Service Update

49560 Vehicle Shutdown No Restart

Reference Number: N162049560
GWM Number: 2049560

Release Date: September 2016
Revision: 00

4580308

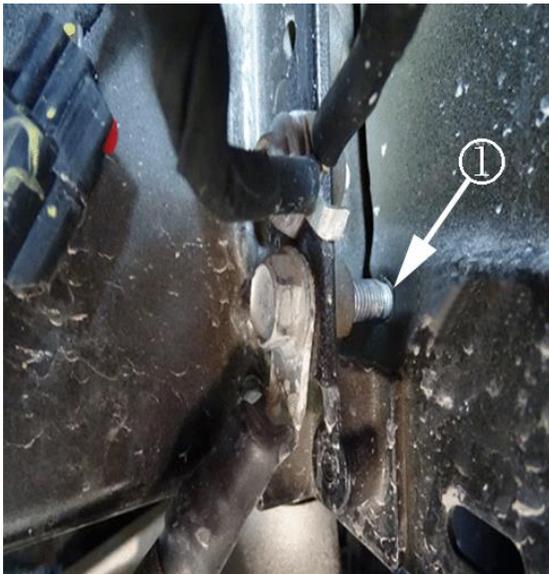
Condition	Certain 2016 model year Cadillac CT6 vehicles may have an incorrect bolt installed on an engine ground that may cause a vehicle to shut down while driving, with no restart.
Correction	Inspect and, if necessary, replace ground G103 bolt.

3. Locate G103.

4. Inspect for the presence of a washer between the head of the bolt and the ground cable terminal.
 - If a washer is present, proceed to the next step.
 - If a washer is NOT present, replace the G103 bolt.

5. Inspect for the end of the bolt bottoming out against the frame (1).
 - If the bolt is NOT bottoming out against the frame, proceed to the next step.
 - If the bolt is bottoming out against the frame, replace the G103 bolt.
6. Attempt to slide a 0.5mm (0.020 in) feeler gauge between the washer and the ground cable terminal.
 - If the 0.5 mm (0.020 in) feeler gauge will NOT slide between the washer and ground cable terminal, proceed to the next step.
 - If the 0.5 mm (0.020 in) feeler gauge will slide between the washer and ground cable terminal, replace the G103 bolt.
7. Verify the G103 bolt is torqued to 22 Nm (17 lb ft).
8. Install the passenger front wheelhouse liner. Refer to *Front Wheelhouse Liner Replacement* in SI.
